DRAFT responses to 2/27/2017 EPA Comments on Excelsior's December 2016 Responses, Excelsior Mining Arizona Gunnison Copper Project, Class III UIC Permit Application

Attachment A

**FIGURE A-9
AQUIFER TESTING
AREA OF INFLUENCE
NSH-013**

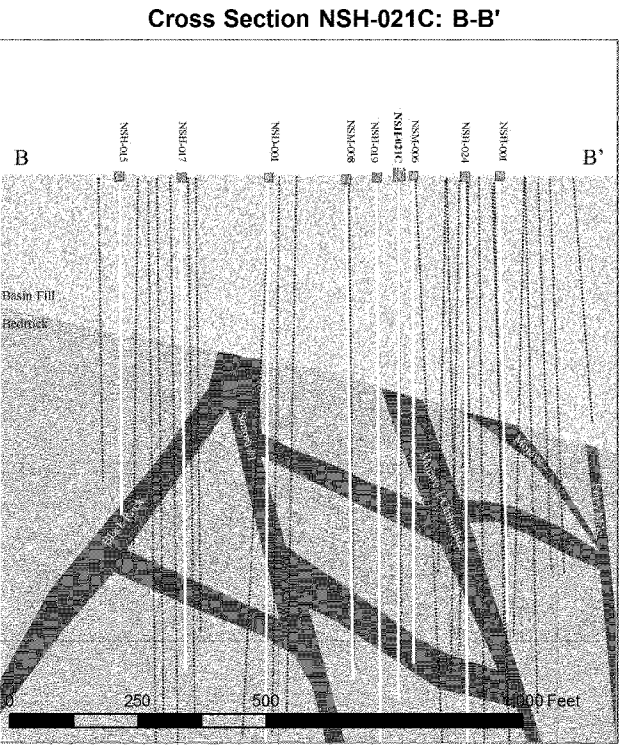
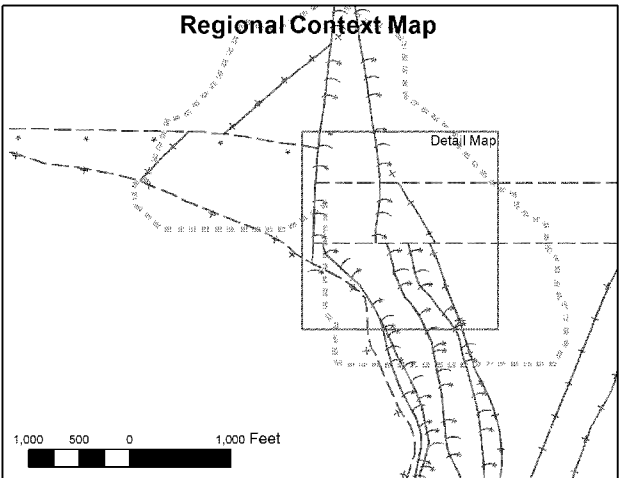
Excelsior should propose monitoring well locations at the western perimeter of the wellfield at a spacing consistent with the PowerPoint (PPT) presentation viewed during the meeting with Excelsior on February 9. In addition, observation wells should be placed to the south of the westernmost HC well in Figure A-7A in Attachment A-1 of the response document. Final proposed locations for HC and observation wells will be subject to EPA approval. The outer observation wells of all well pairs and intermediate monitoring wells should also be equipped with conductivity sensors to monitor for movement of ISR fluids beyond the wellfield. The PPT presentation viewed during the February 9th meeting should be included in the updated application and the application should be updated to be consistent with that presentation, subject to final EPA approval and permit conditions.

The location of the outer IMW's for Stage 1 is based on the aquifer testing that has already been completed in the in the proposed Stage 1 mining area. This aquifer testing shows the degree of connectivity between the pumping well and the surrounding observation wells. Figures A-9, A-10, and A-11 show the areas of influence of NSH -013, NSH -021C, and NSH -024, which are located within Stage 1 operations. The shaded areas represent the interpreted areas of influence, based on responses in observation wells. The composite area of influence of these three wells, as shown on Figure A-12, covers all of Stage 1. Figures A-9, A-10 and A-11 provide cross sections through each of the tested wells (NSH -013, NSH-021C, and NSH -024). The intent of the cross sections is to show how the fault network at the site results in hydraulic connections over long distances. Bedding plane fractures, which are shown as dipping to the east, are lesser, but significant flow paths.

The general principle is to locate outer IMW's along the more conductive fluid pathways (bedding parallel and structures), at distance of several hundred feet from the active mining area, in a radial pattern spatially distributed and surrounding the mining area. Irrespective of the IMW's exact location, the aquifer test results show that all the structures are hydrologically well connected, and as long as the IMW intersects either a structure or bedding parallel feature, it should respond to and detect potential migrations outside the active mining area in that direction.

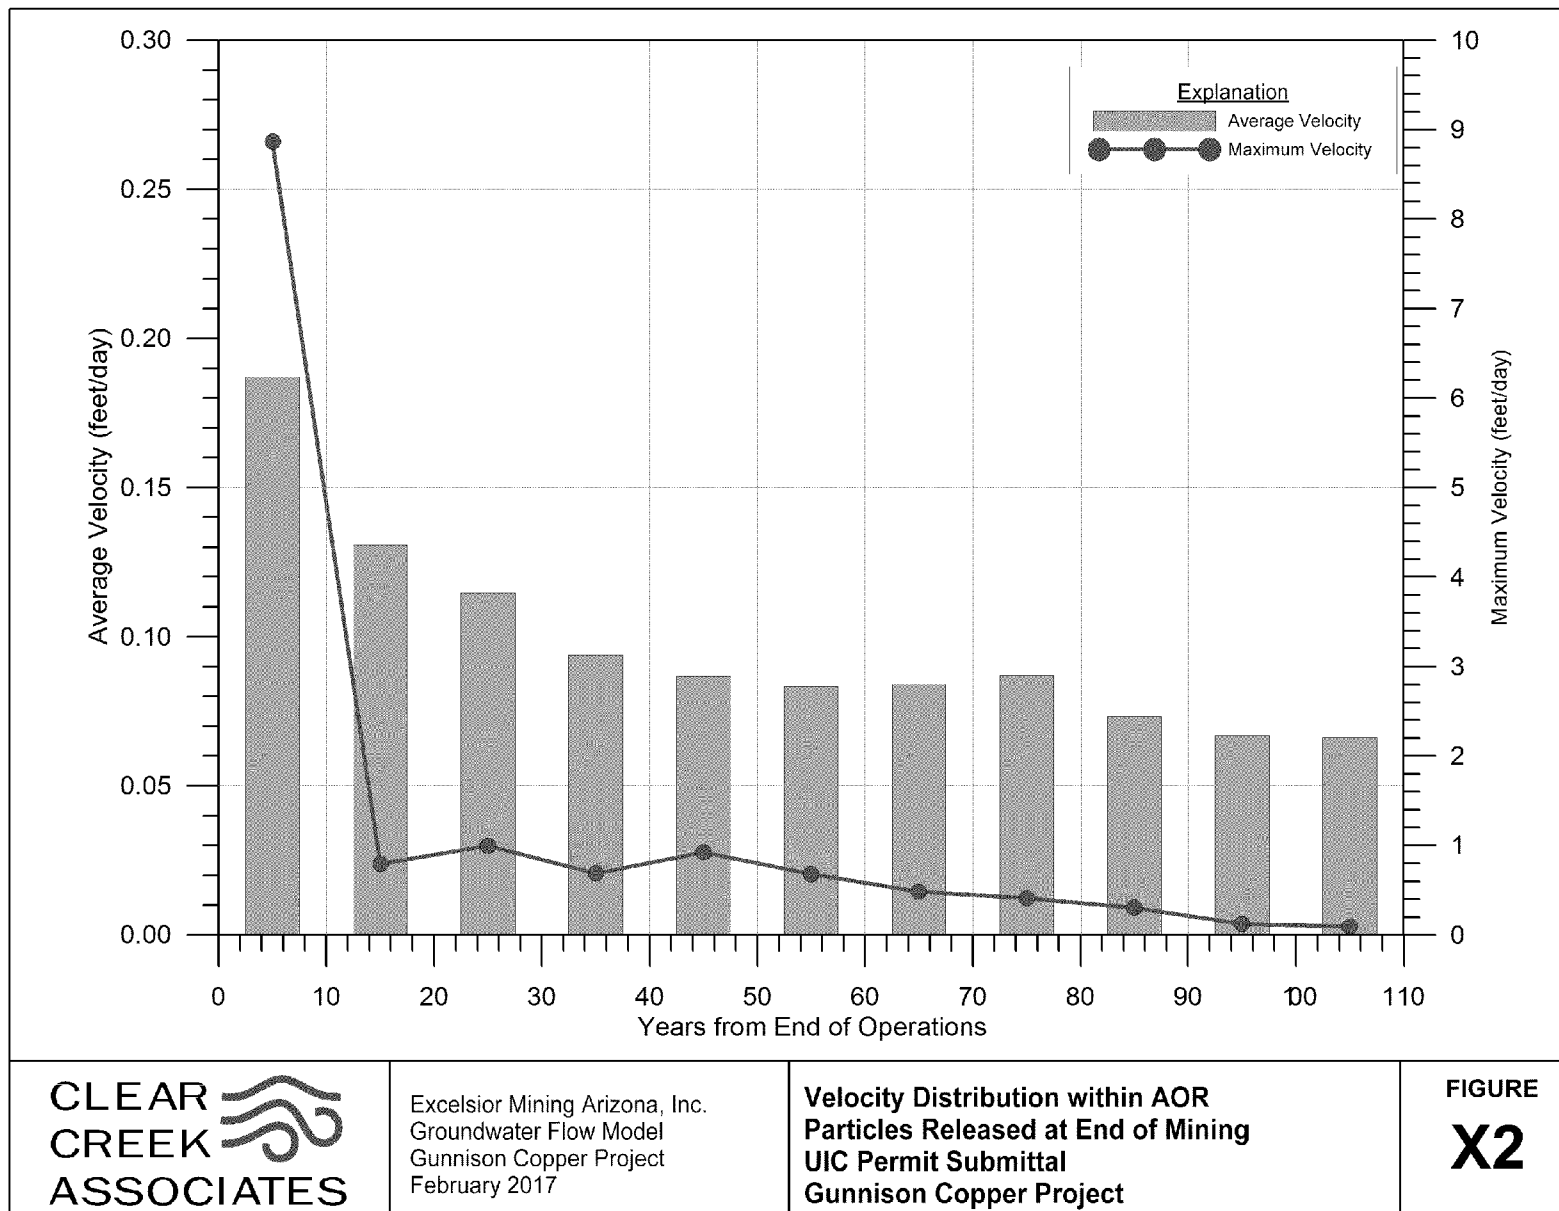
Excelsior should provide an estimate of average and maximum groundwater flow velocities within the AOR beyond the wellfield perimeter and the estimated travel time from the wellfield to the point of compliance (POC) wells at the eastern AOR boundary.

Figure X-2 illustrates a histogram of the velocity distribution, showing particle velocities prior to leaving the AOR. As expected, particle velocities drop as drawdown conditions rebound to static conditions after mining ends. Average velocities drop from around 0.18 feet per day (ft/d) in the

first decade to less than 0.10 within 20 years. Maximum velocities also decline over that period from 8 ft/d to less than 1 ft/d.
